UNION CARBIDE CORPORATION

Ref: (a) UCC Ltr. 12/28/78⁷ Application To Amend SNM-639.

Our letter of application (Ref. (a)) is hereby changed in accordance with discussions held between UCC & USNRC regarding assurance of criticality safety.

TOLERANCES ±	UNION CARBIDE CORPORATION CORPORATE RESEARCH LABORATORY TUXEDO, NEW YORK		
DRAWN: M.R. 5 MAY 78	STORAGE RACK		
CHECKED:	SCALE: 1" = 1/4"	SIZE: A	DRAWING NO.: 101349
DATE:

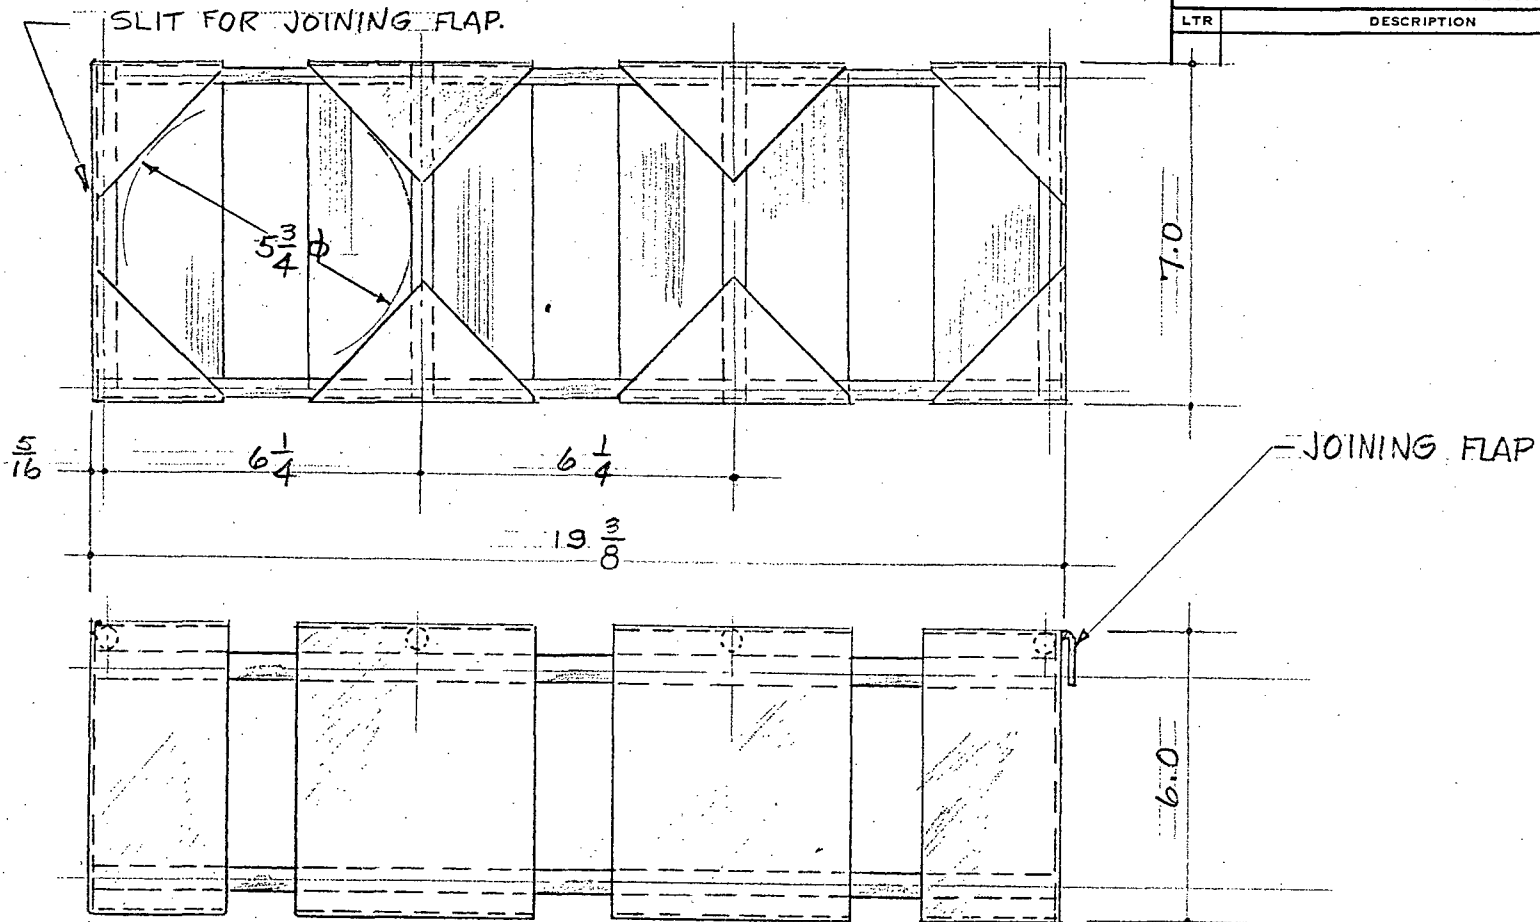
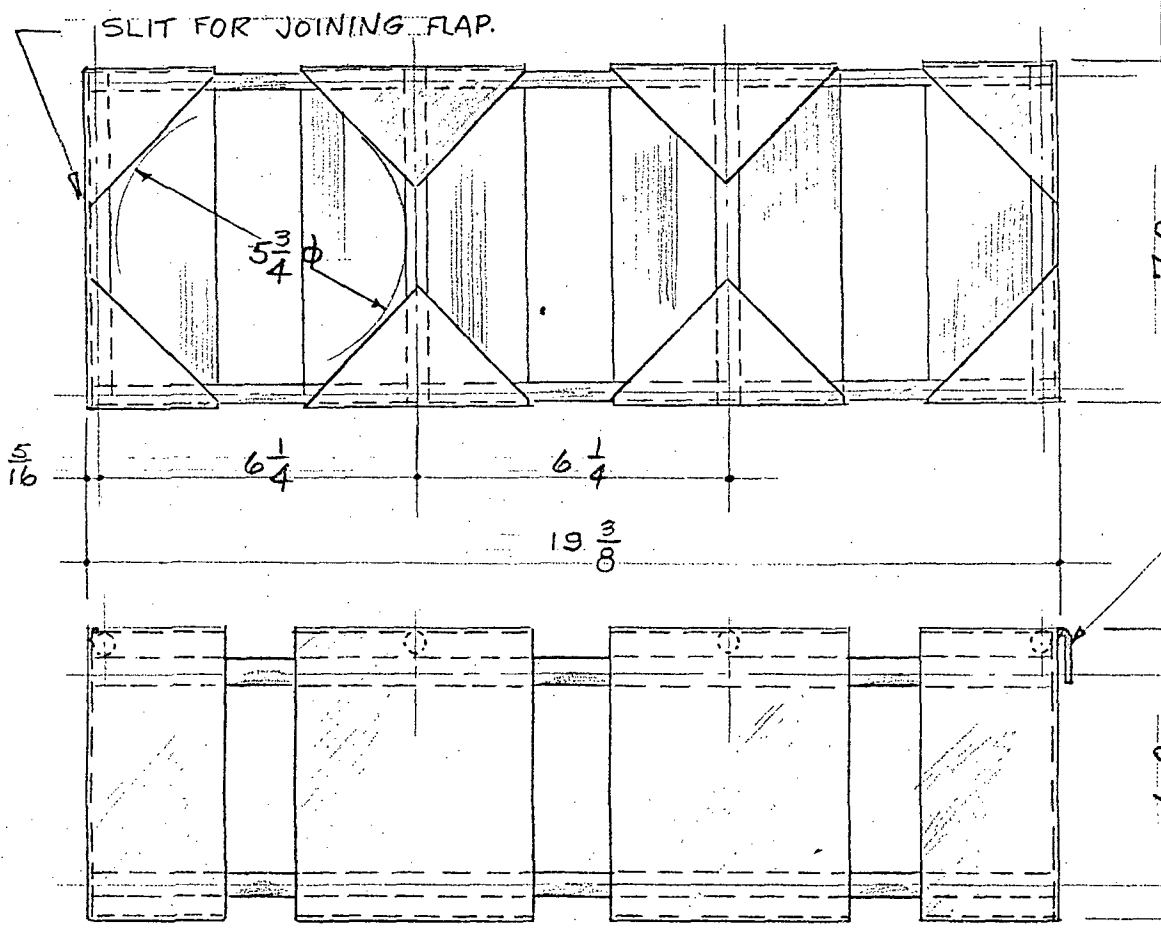
1. Each waste container is a right cylinder of aluminum metal, 5.25" OD x 0.125" wall (minimum) (I.D. < 5.0"). There is no restriction on height but each cylinder will typically be < 18" high.
2. Aluminum waste containers will be stored in a linear array within the waste storage hot cells which are not used for storage of boro-silicate glass bottles containing U-235. A diagram of a typical aluminum waste container storage is shown on the enclosed drawing.
3. Aluminum waste containers, one at a time, will be filled in an isotope processing cell and will be moved to a hot cell which is equipped with a rack for storage of the aluminum containers. For disposal, the aluminum waste containers will be placed in 55 gallon 17H steel drums (2 per drum, 300 gms U-235 max.). Arrangement of drums will be as shown in the enclosed drawing.
